10/042,057

Manfred Baldauf

Office Action Summary

DETAILED ACTION

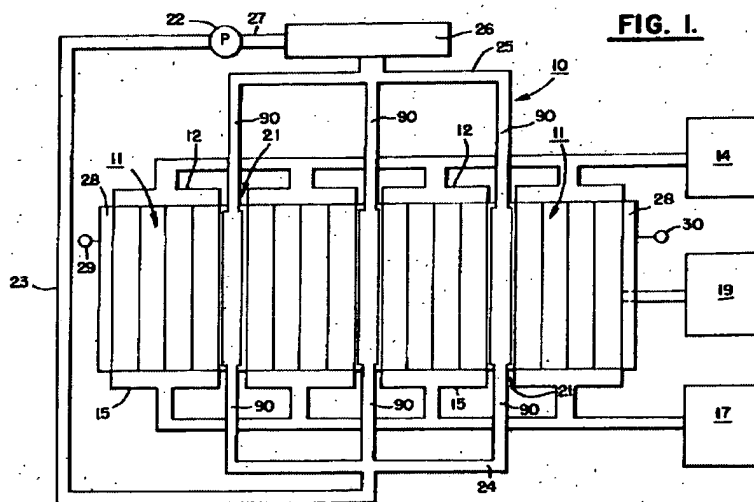
The reference is silent to at least two of the subsystems having respective cooling circuits, configured to be connected by series or parallel.

However, Wittel teaches that it is conventional to employ subsystems having respective cooling circuits in series/parallel as illustrated in Figure

in order to maximize heat transfer from the fuel cell stack to the coolant without undue manufacturing and assembly tolerances and to avoid shunt currents without the need for additional electrical isolation form adjacent cells of the fuel cell stack. See column 3, lines 5-25.

Therefore, it would have been obvious to one of ordinary skill in the art at the time the instant invention was made to employ the cooling circuits of Wittel in the fuel cell stack of Einhart in view of Chandran, in order to maximize heat transfer from the fuel cell stack to the coolant without undue manufacturing and assembly tolerances and to avoid shunt currents without the need for additional electrical isolation from adjacent cells of the fuel cell stack.

However, Wittel teaches that it is conventional to employ subsystems having respective cooling circuits in series/parallel illustrated as in Figure 1:

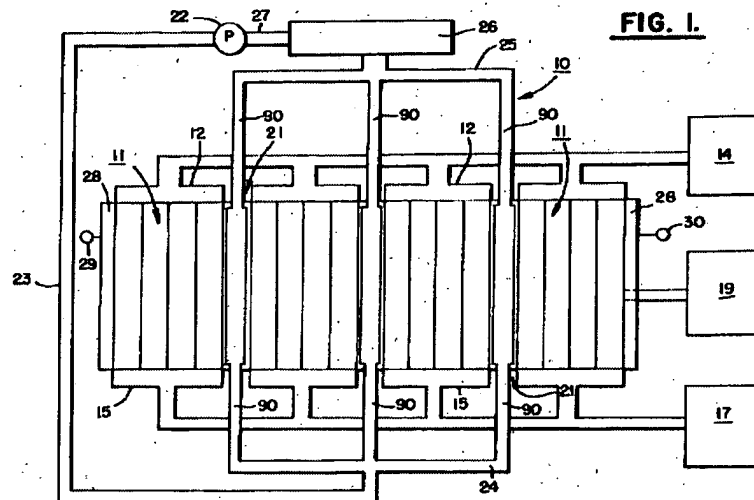
The reference is silent to at least two of the subsystems having respective cooling circuits, configured to be connected by series or parallel.

in order to maximize heat transfer from the fuel cell stack to the coolant without undue manufacturing and assembly tolerances and to avoid shunt currents without the need for additional electrical isolation form adjacent cells of the fuel cell stack. See column 3, lines 5-25.

Therefore, it would have been obvious to one of ordinary skill in the art at the time the instant invention was made to employ the cooling circuits of Wittel in the fuel cell stack of Barton in view of Chandran, in order to maximize heat transfer from the fuel cell stack to the coolant without undue manufacturing and assembly tolerances and to avoid shunt currents without the need for additional electrical isolation form adjacent cells of the fuel cell stack.
